Subject: FW: Ref 22630 - SBEM - Tower 42, Old Broad St. London, EC2N 1HQ

Please see below crane plan showing set up position, MRI pick & install location.

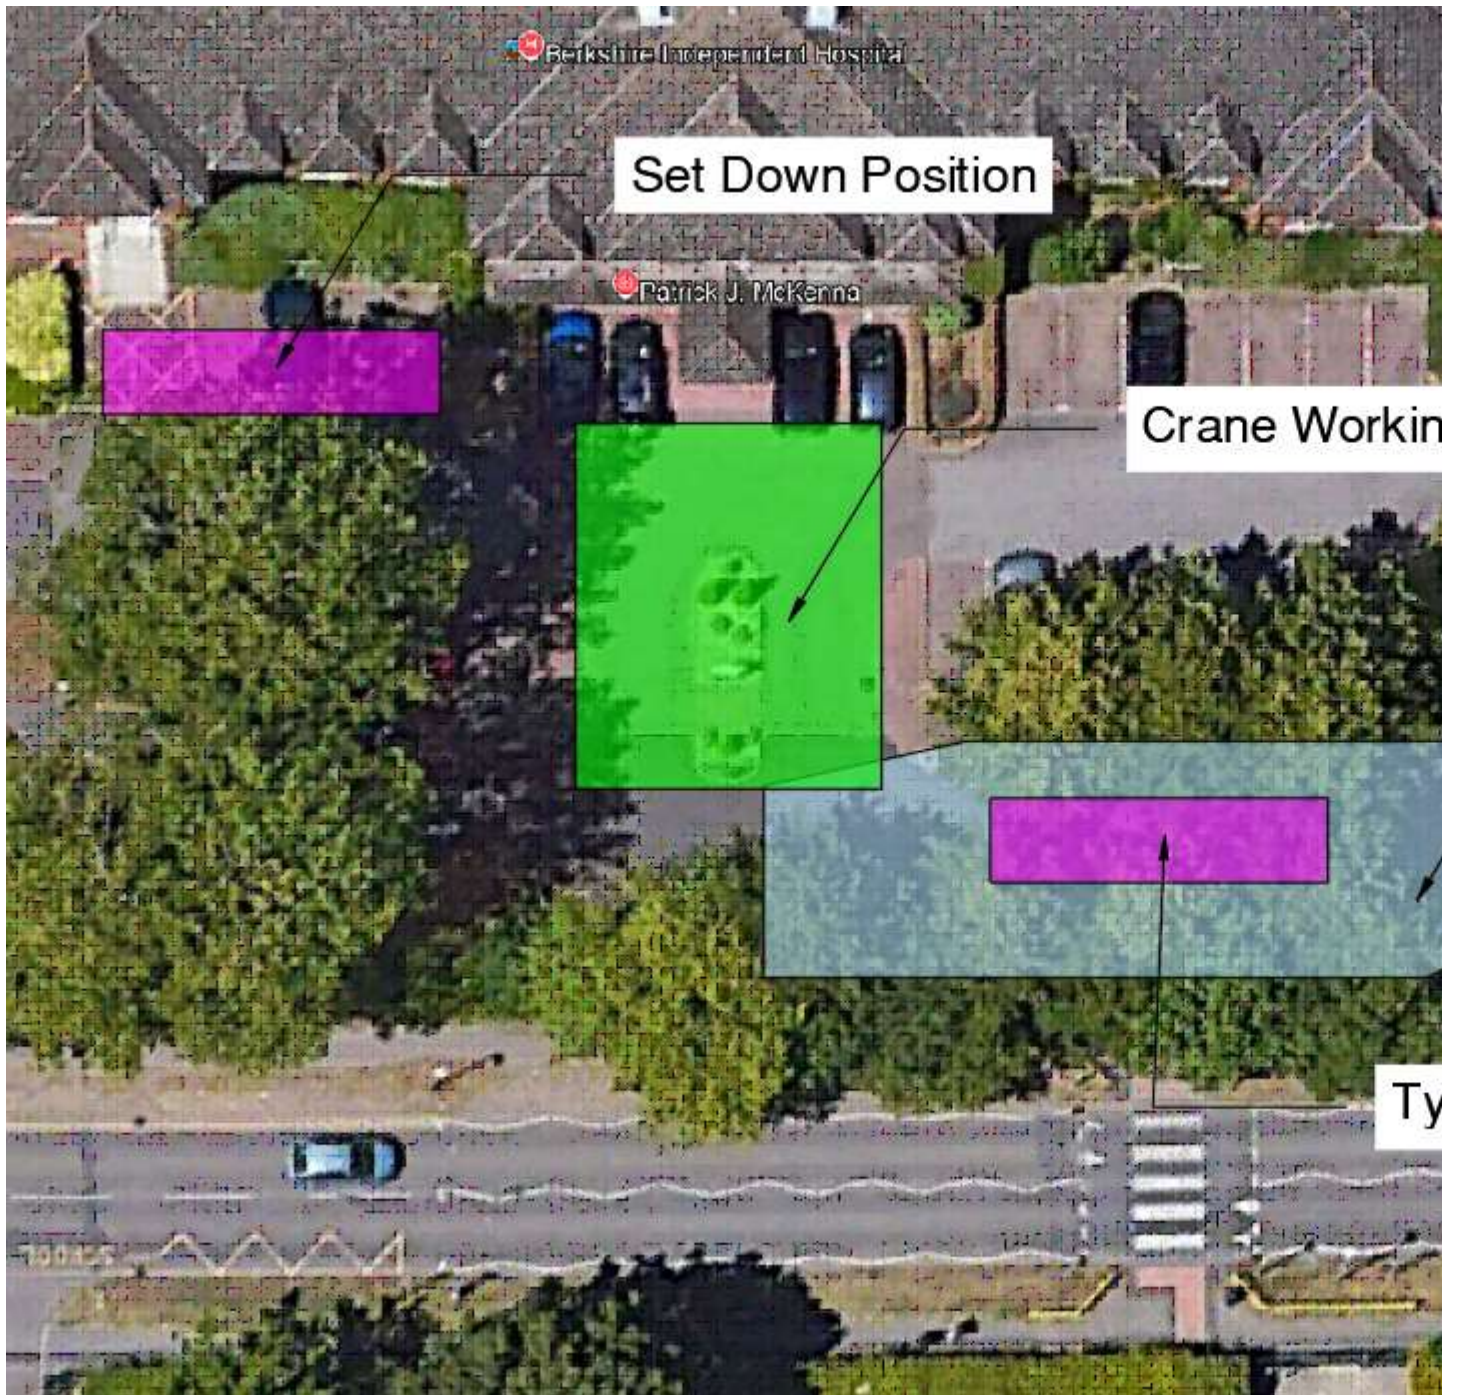
I have shaded an area we would need to tree cut back, crane height 4m, so 4.5m clearance would be advised (Road + Pavement width).

Our crane is not as wide as your units so you may need extra space.

We would need full height clearance in the pick area, so no branches overhang the lift.

Access road (Tree cut back full width road & pavement to min 4.5m clearance)

Any overhanging branches directly above set down area to be removed.

(At time of visit, it looked ok, but there could be more growth)

Island, signs, tree to be removed and area made suitable for crane set up.

Note: Crane will need to set up on block paving, client would need to confirm ground suitable for crane axle & o/rigger loadings.
